Your Ref: APP/12/00610

Our Ref: PLAN-000688

Proposal: Engineering works to improve drainage, groundworks to remodel golf course and landscaping works to increase land levels.

Site: Portsmouth Golf Club, Crookhorn Lane, Waterlooville PO7 5QL.

Southern Water MapGuide Browser

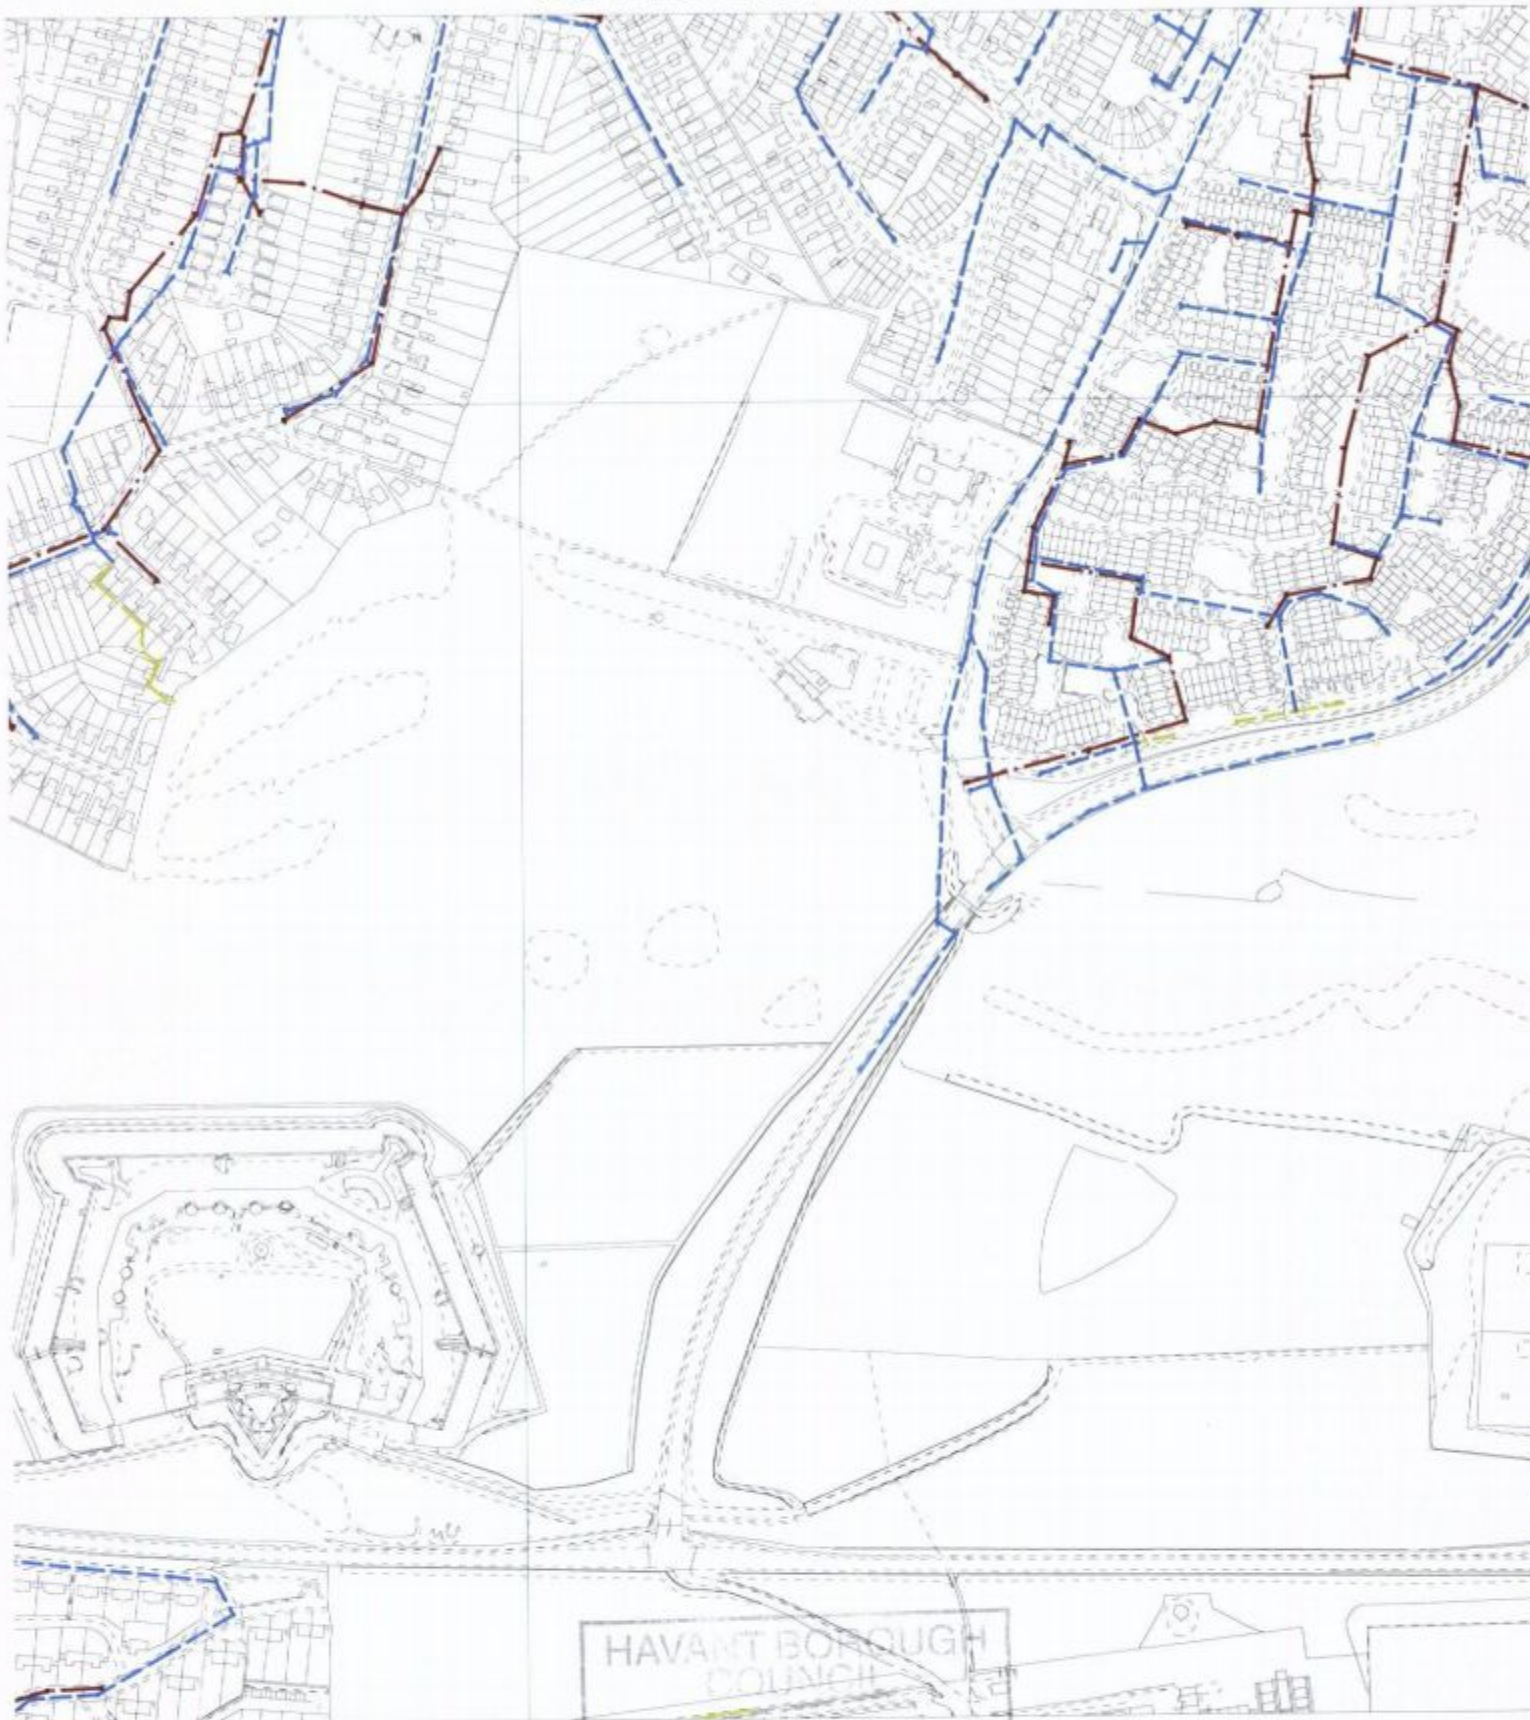
Please find attached a plan of the sewer records showing the approximate position of surface water sewers in the immediate vicinity of the site. The exact position of the surface water sewers must be determined on site by the applicant.

- No new soakaways should be located within 5 metres of a public sewer.
- No development or new tree planting should be located within 3 metres either side of the centreline of the surface water sewers and all existing infrastructure should be protected during the course of construction works.
